1241 W. Calle De La Plaza
Sahuarita, Az. 85629
March 8, 2006
Phone (520) 625 - 3327

Dorothy Hains, Utilities Engineer
Arizona Corporation Commission
1200 West Washington Street
Phoenix, Az. 85007

Docket Nos. W-01583A-04-0178, et al.

W-01583A-04-0178
W-01583A-05-0326
W-01583A-05-0340

Pg 6

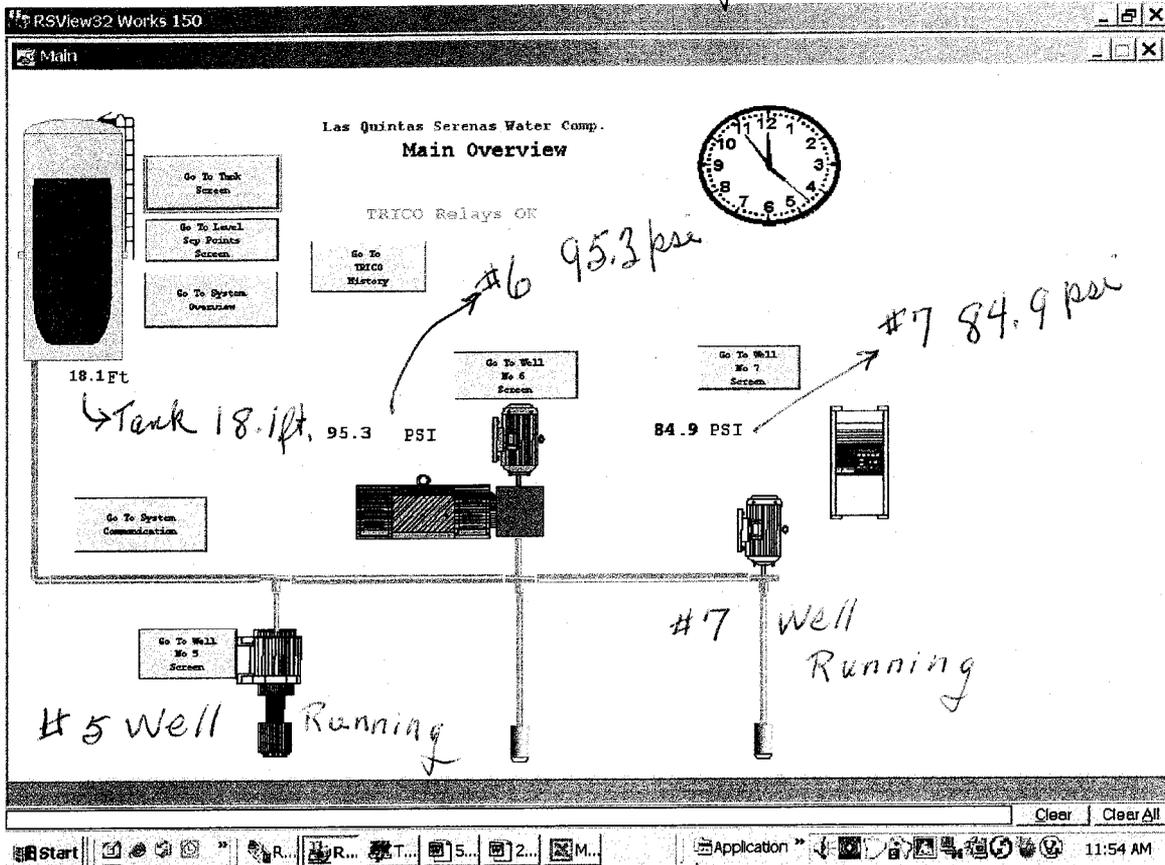
#5 & #7 wells running

Field measurements March 6, 2006 by John Kay:
